SUPPLEMENTAL RESPONSE TO REQUEST FOR ADDITIONAL INFORMATION

US-APWR Design Certification

RAI NO.: NO. 490-3732 REVISION 0
SRP SECTION: 03.08.01 – Concrete Containment
APPLICATION SECTION: 3.8.1
DATE OF RAI ISSUE: 11/23/2009

QUESTION NO. 03.08.01-09:

Figure 1 Section View and Stresses

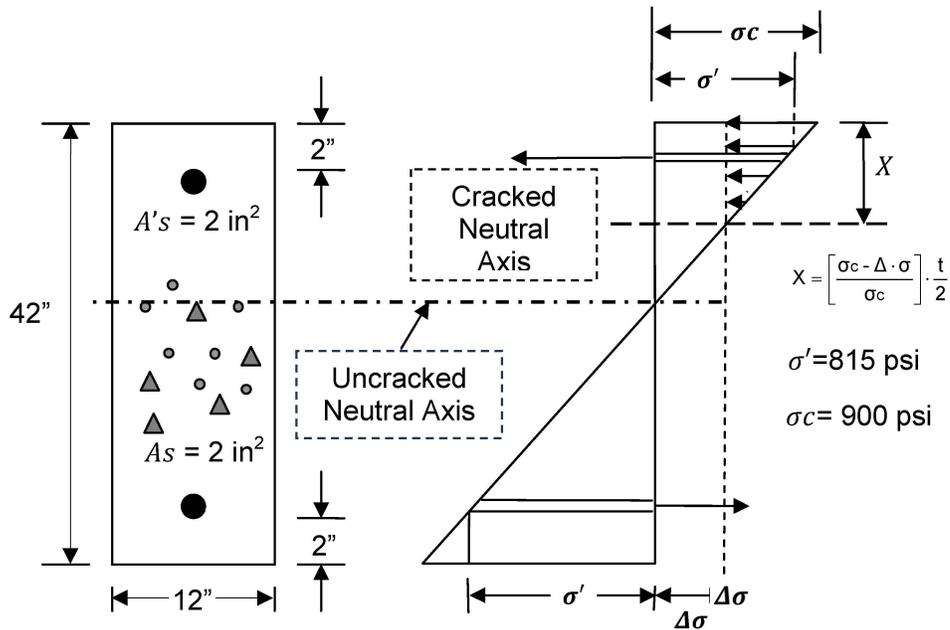
The staff finds that MHI's response does not clearly indicate how thermal forces and moments are reduced according to the concrete cracking depth. In MHI's response, a notation, $\sigma c1$, is used to denote the extreme fiber stress of the concrete; however, in the example given at the end, an additional notation, $\sigma c2$, is introduced without any explanation. MHI is requested to clarify this confusion. Also, MHI is requested to provide a calculation example that is taken from the US-APWR design, and that will have numerical results clearly showing the amount of reduction in forces and moments and the concrete cracking depth.

The following example is provided to show how concrete cracking in the PCCV cylindrical section is considered. The stress across a concrete section is calculated as an un-cracked section initially and then the stress due to concrete cracking is calculated to adjust the concrete section given the effects of the cracked concrete behavior.

The example presented herein is an example of a PCCV concrete section when subjected to a thermal gradient with reinforcement provided on both faces and concrete cracking is considered.

Uncracked concrete stress, σ_c :

$$\sigma_c = \frac{1}{2} \alpha E_c \Delta T = 900 \text{ psi}$$

Cracked concrete stress at rebar location, σ' :

$$\sigma' = \sigma_c \left(\frac{\frac{t}{2} - 2''}{\frac{t}{2}} \right)$$

$$\sigma' = 900 \left(\frac{21-2}{21} \right) = 814.3 \text{ psi, use } \sigma' = 815 \text{ psi}$$

Force Equilibrium to Solve for Change in Stress, $\Delta\sigma$:

Reinforcing Tension – Initial Concrete Compression Force + Concrete Compression Reduction = 0

$$A_s f_s - \frac{\sigma_c}{2} \left(\frac{t}{2} \right) b + \frac{\Delta\sigma b}{2} \left[\frac{t}{2} + \frac{t}{2} \left(\frac{\sigma_c - \Delta\sigma}{\sigma_c} \right) \right] = 0$$

$$2.0(815 + \Delta\sigma)10 - 2.0(815 - \Delta\sigma)(10 - 1) - \frac{900}{2}(21)(12) + \Delta\sigma\left(\frac{12}{2}\right)\left[21 + 21\left(\frac{900 - \Delta\sigma}{900}\right)\right] = 0$$

$$\Delta\sigma = 511.9 \text{ psi, use } \Delta\sigma = 512 \text{ psi}$$

Due to the effects of concrete cracking have on the cross section, the neutral axis is shifted to reflect such conditions. The cracked neutral axis is therefore calculated as follows.

$$X = \left(\frac{\sigma_c - \Delta\sigma}{\sigma_c}\right) \frac{t}{2} = \left(\frac{388}{900}\right) 21 = 9.05 \text{ in.}$$
